WORKSHOP AGENDA

Planning Commission

August 13, 2024 @ 5:30 PM

Item #: 5. Item Title: Site Plan – Chipotle Mexican Grill – New Building of 2,300 Square Feet on 0.93 Acres. Requested by DSG. Property located at Murfreesboro Road & Veterans Memorial Parkway (Tax Map 14, Parcel 72.15). C-2 (Highway Service) Zoning District. Property owned by Woodhaven La Vergne, LLC.

DATE	DESCRIPTION	REV.	BY	DATE
		1		
		2		
		3		
		4		
		5		
		6		
		7		
		8		
		9		
		10		
		11

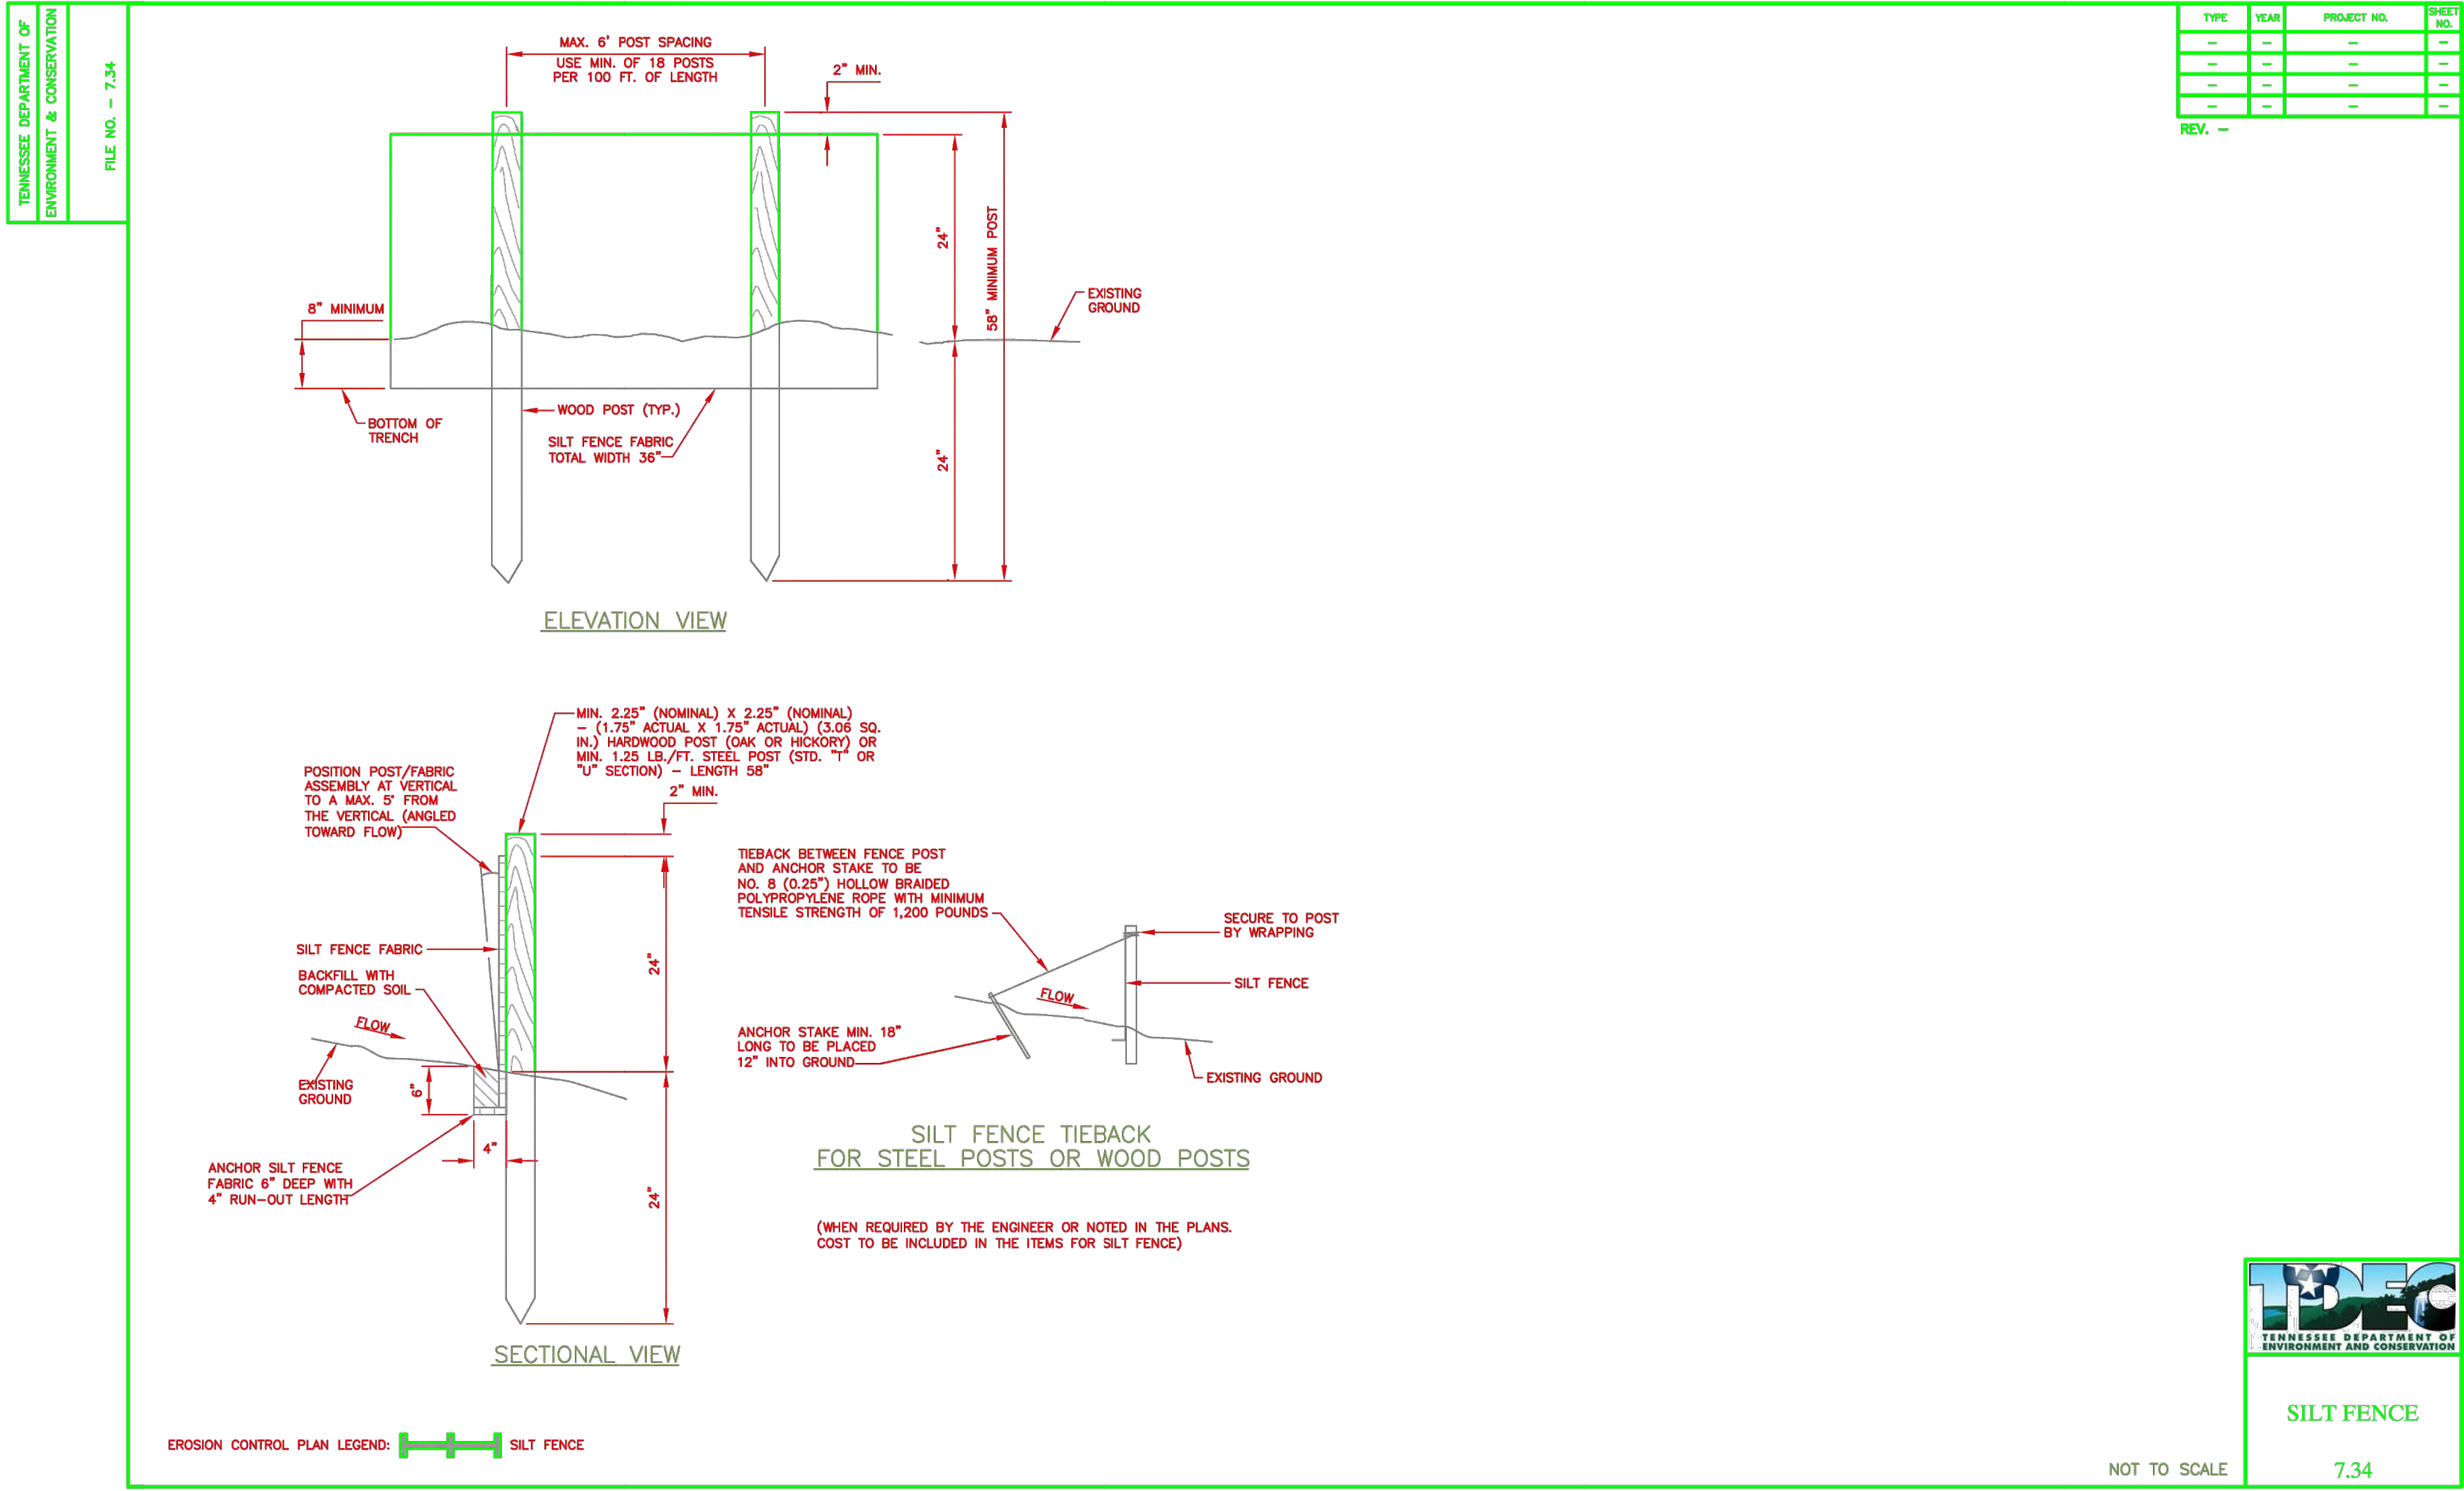
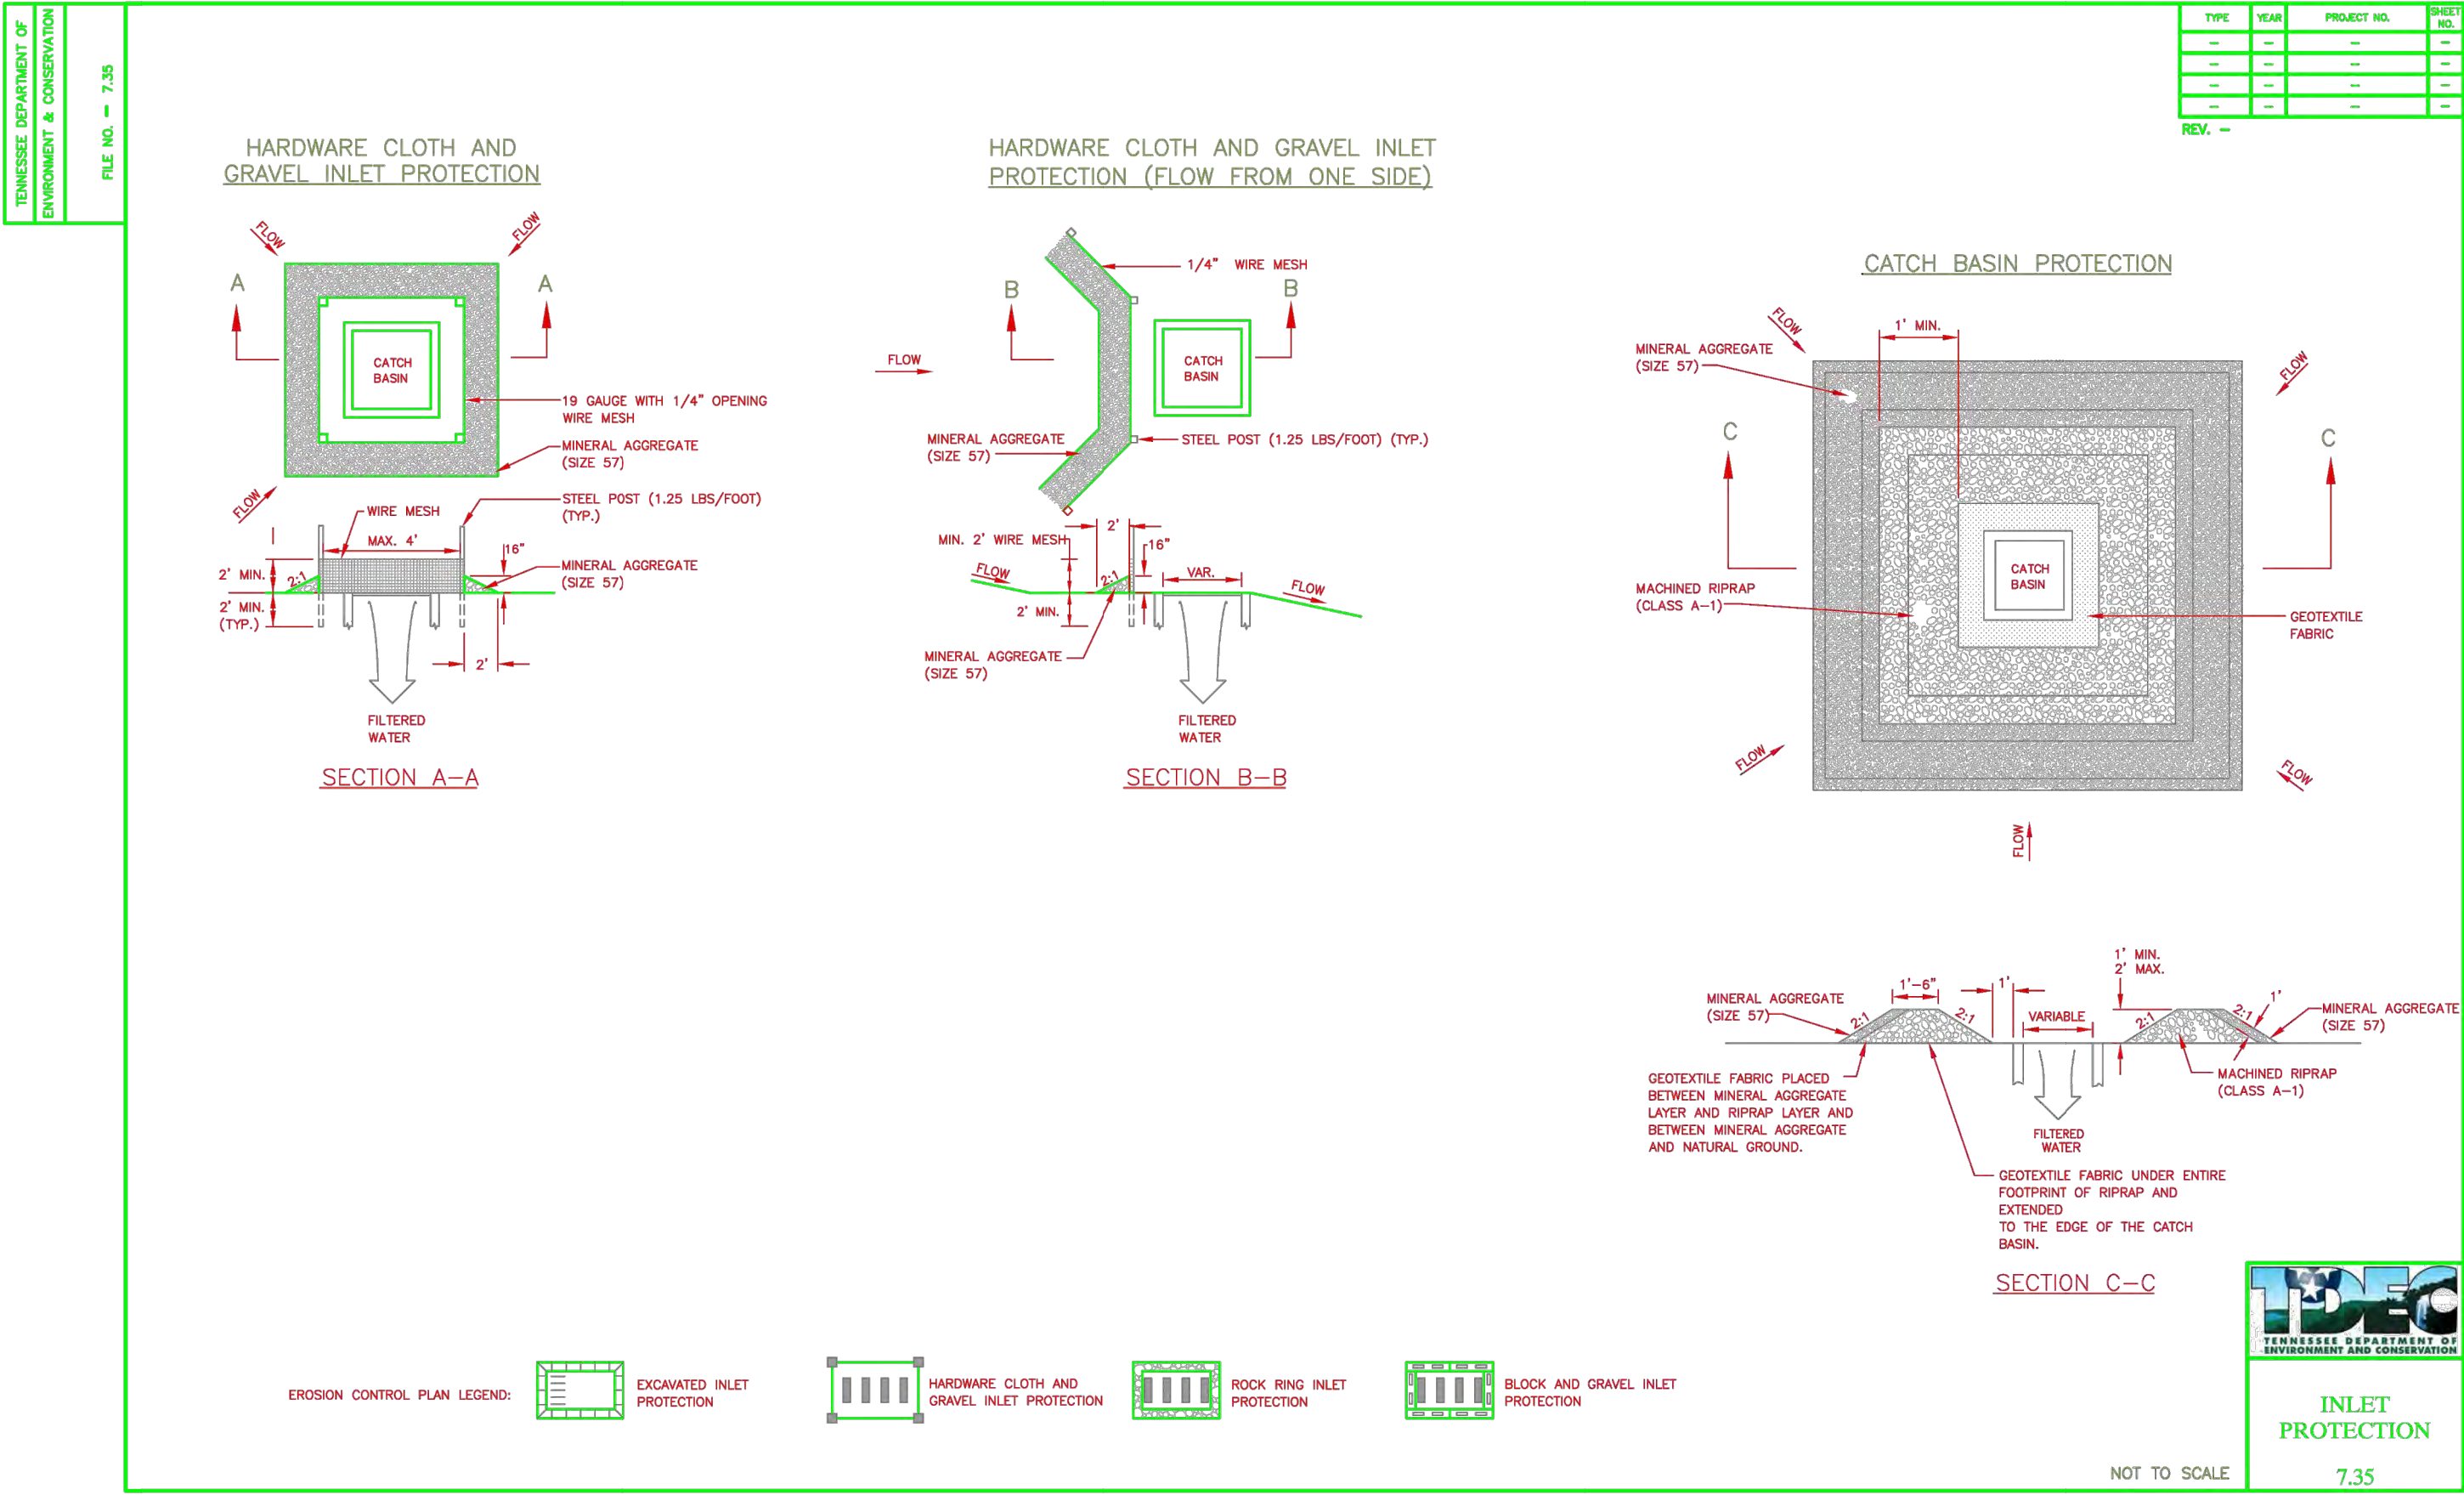
8. (Sheet CES-3.0) Show construction entrance on initial erosion control plan rather than intermediate. It will be required for initial inspection.
9. (Sheet CES-3.0) Show location of SWPPP box on initial erosion control plan.
